RE: Rezoning File #D02-02-20-0094;
100 Steacie Drive

100 Steacie Development Application

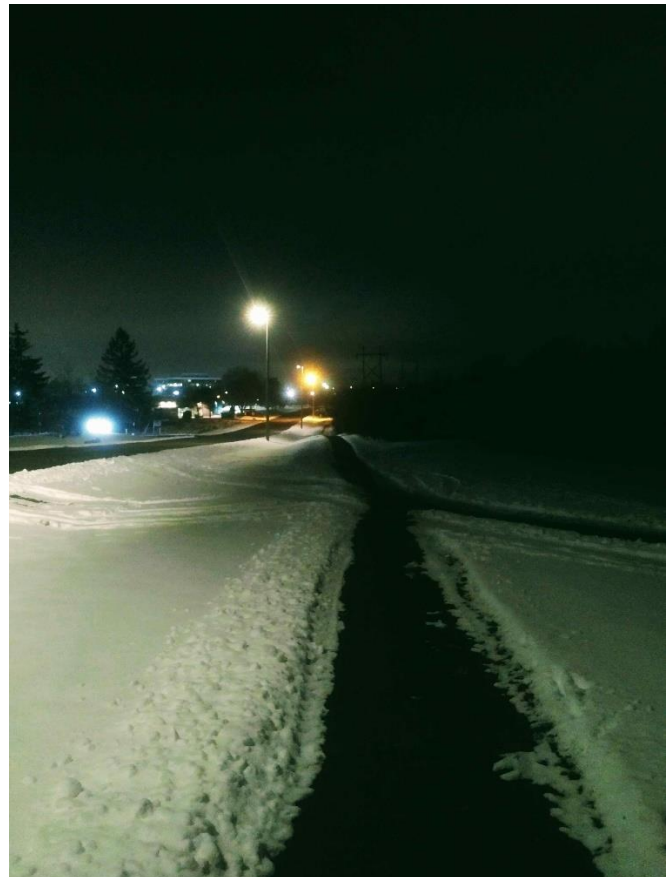
There are assumptions that the walking trails from the site in the direction of March/Teron and to the rest of the Beaverbrook Community are adequate for both pedestrians and cyclists.

- While the walking trails marked in green in the diagram above have been cleared of snow recently, it is not clear whether this is being done as part of the sidewalk network Winter Maintenance Plan or on what priority.

- The current trails leading to/from 100 Steacie have substantial elevation changes which could be treacherous if at all icy and are currently in poor condition. The width of these trails is insufficient to support more than casual walking and are not suitable for a mix of several hundred new residents walking and cycling.

- **Is the City of Ottawa and/or the Rail Line owner and/or the owner (Nordion) of Station Rd prepared to commit to providing the walking and cycling infrastructure to be delivered on completion of the project?**
- **Is the City of Ottawa prepared to upgrade these paths for dual pedestrian & cycling traffic and safe elevation changes and to commit to prioritized winter snow maintenance?**
- **Is the City of Ottawa and/or the Rail Line owner and/or the owner (Nordion) of Station Rd prepared to fund the cost of a safe pedestrian/cyclist level crossing from the property to Station Rd?**
